Staff Summary Report

SUBJECT: Hold a public meeting for a Development Plan Review for ARIZONA ENVELOPE WAREHOUSE EXPANSION located at 7248 South Harl Avenue.

COMMENTS: Request for **ARIZONA ENVELOPE WAREHOUSE EXPANSION (PL070210)** consists of a 17,166 sf. warehouse addition to an existing 47,520 sf. warehouse and manufacturing building on 3.04 net acres in the GID, General Industrial District and the SWOD, Southwest Overlay District. The request includes the following:

DPR07262 – Development Plan Review including site plan, building elevations, and landscape plan.

Sheet No. A3.01

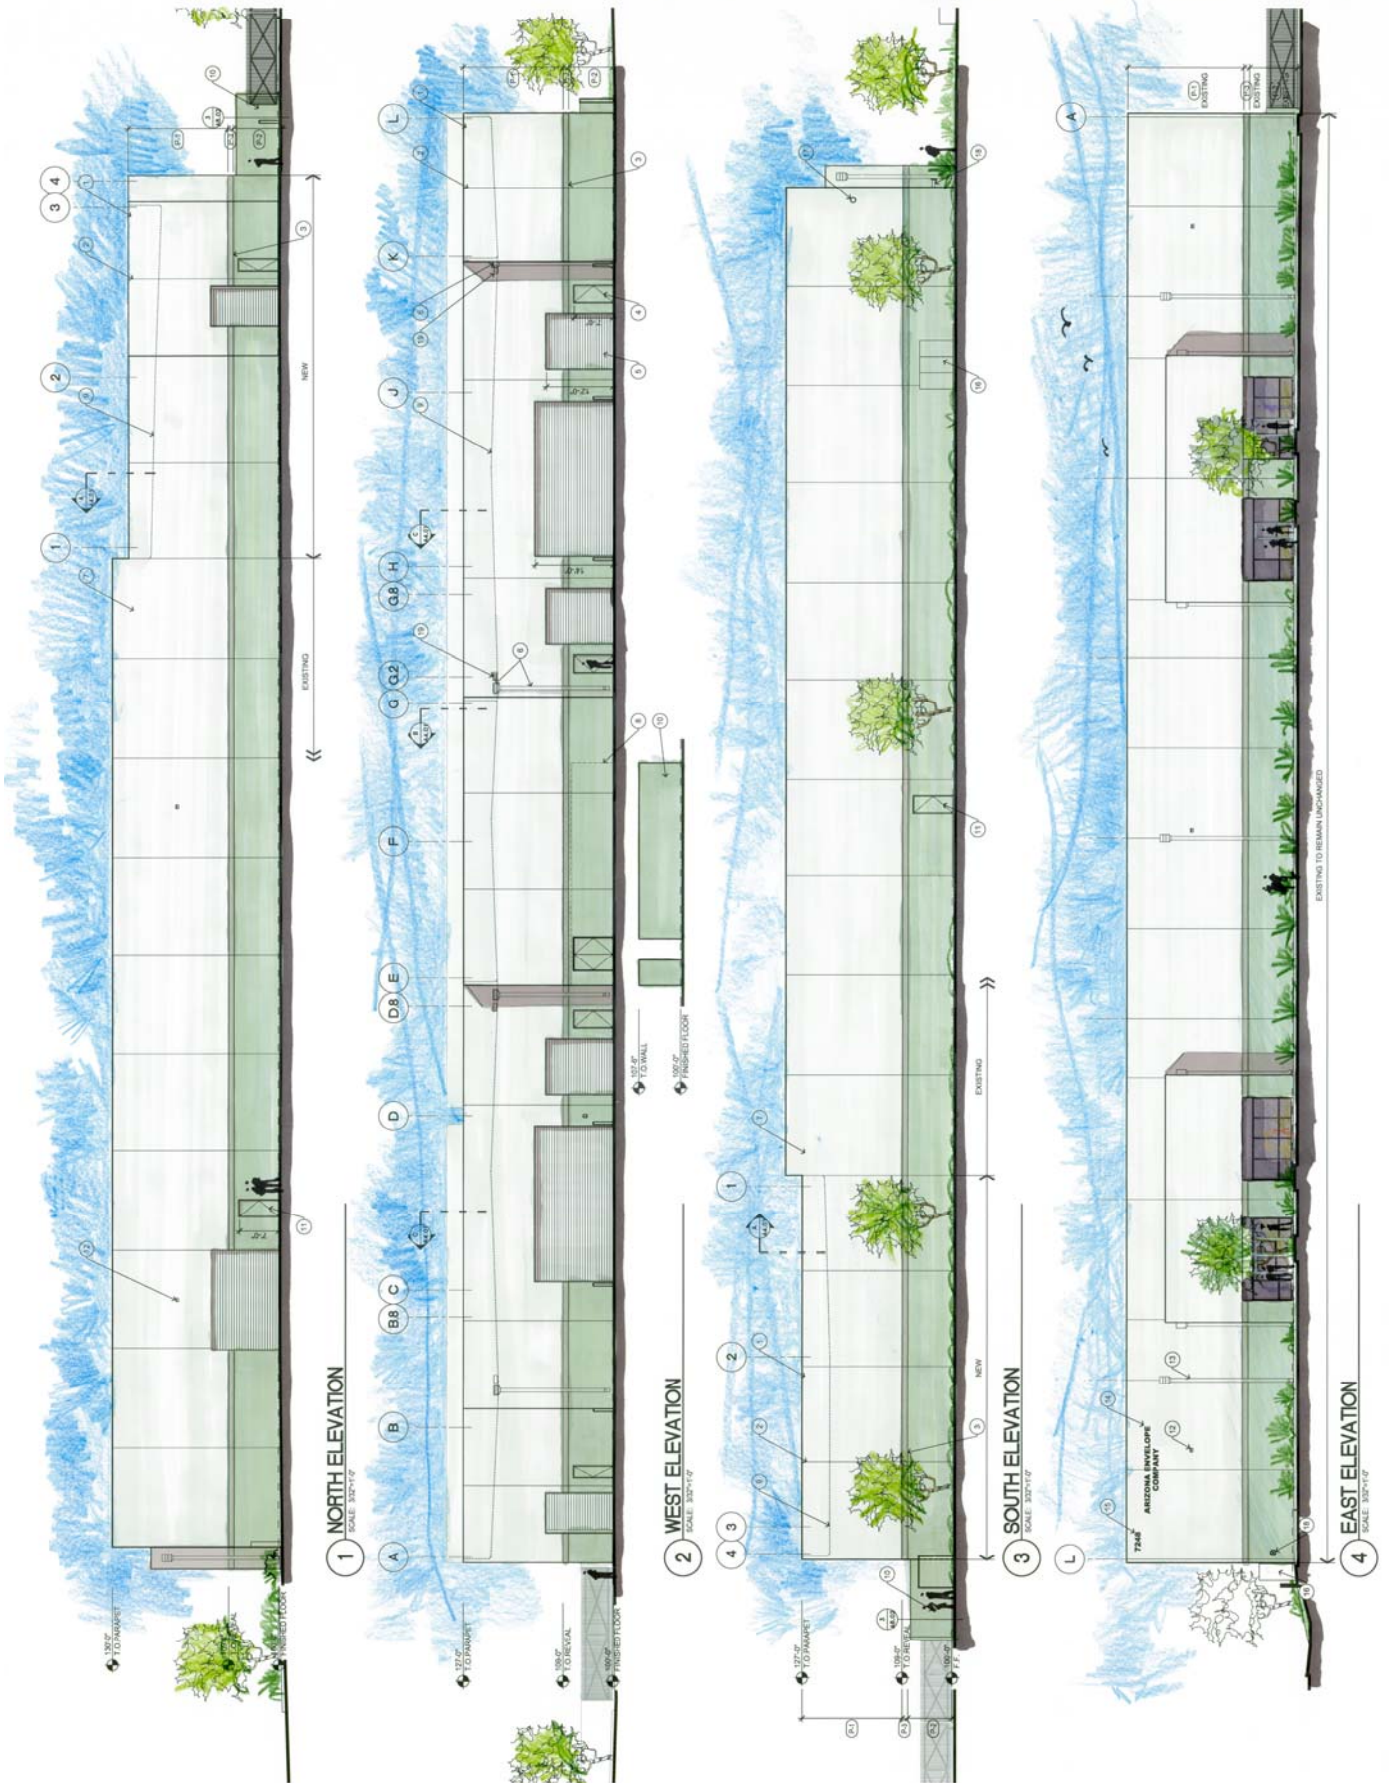
7. Provide secure roof access from the interior of the building. Do not expose roof access to public view.
8. Exposed roof drainage overflow and downspout system as designed is acceptable. Provide concrete splash blocks at outlets.
9. Incorporate lighting, address signs, incidental equipment attachments (alarm klaxons, security cameras, etc.) where exposed into the architectural design of the building elevations.
10. Existing exposed electrical service entrance section on the south of building may remain in place,

undisturbed, as long as it is not enlarged. If the S.E.S. is enlarged or in some way has its exterior appearance modified, relocate the entire fixture inside the building.

11. Exposed conduit, piping, etc. is not allowed on the exterior elevations unless a creative conduit surface design that compliments the architecture is separately reviewed and approved by the Development Review Commission.

DATE	09-22-07
JOB NO.	3585
DRAWN BY:	MCO
DESIGNED BY:	TMO
CHECKED BY:	TMO
SCALE:	1" = 20'
SHEET NUMBER	C-2
OF	3

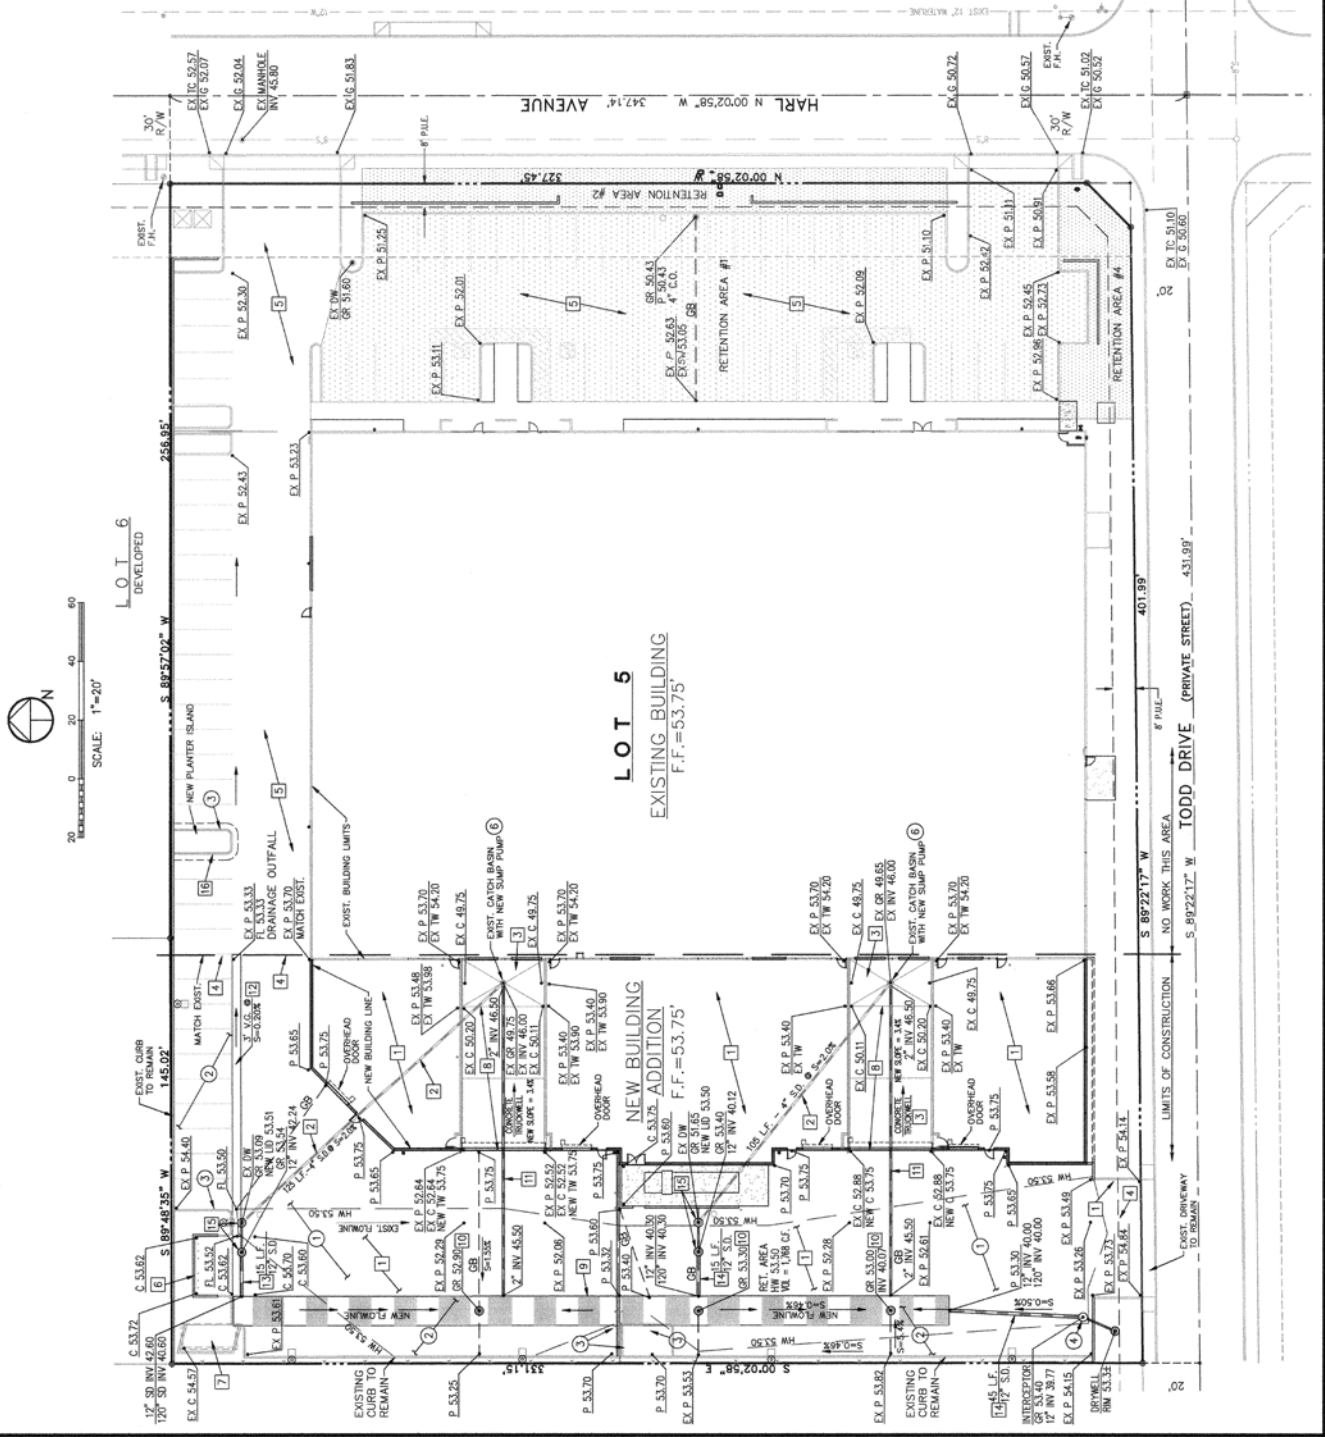
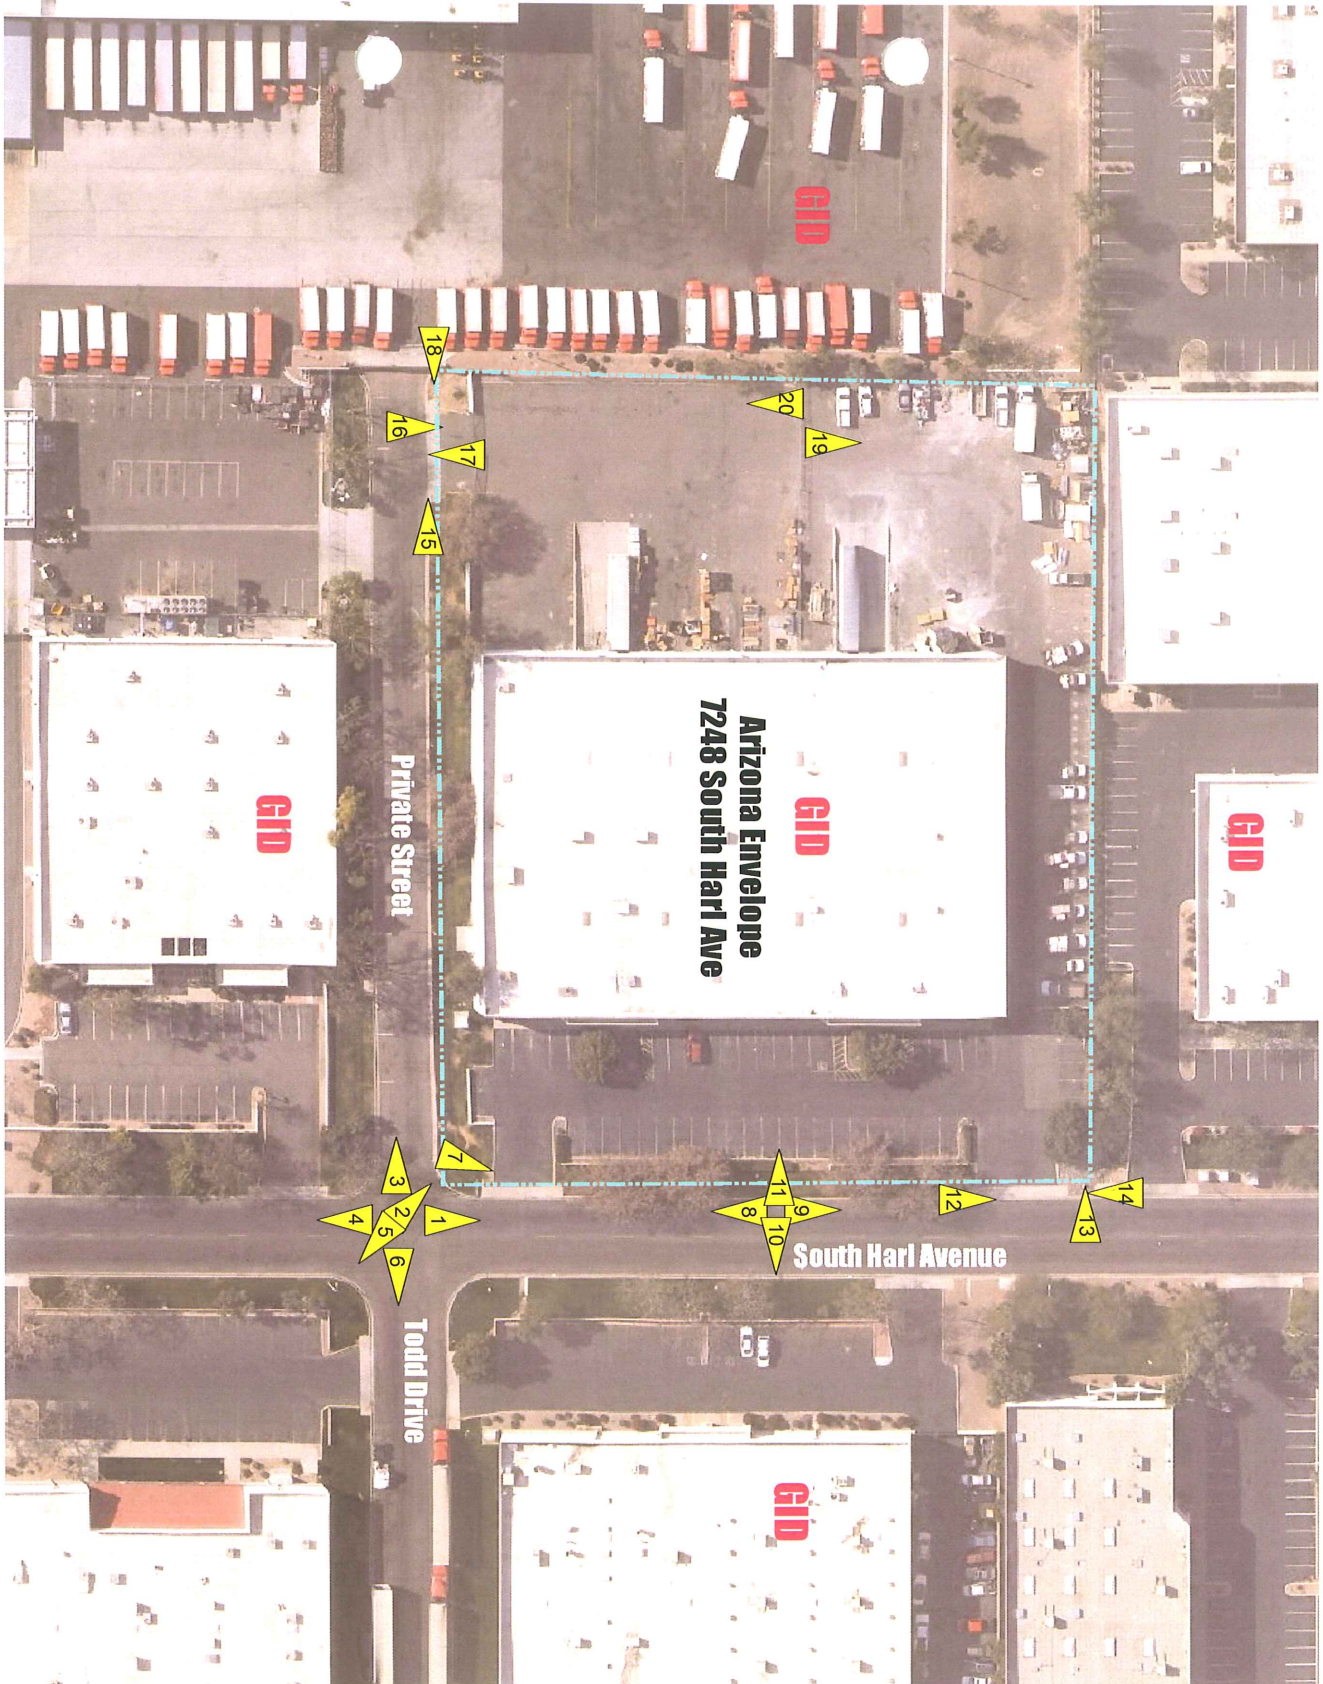
- Provide correct net site area on Grading and Drainage Plan, sheet C-1. Net site area indicated is high.
- Provide one non-deciduous tree of minimum 24" box installation size per each landscape island. Provide at least five groundcovers in each of the landscape islands.
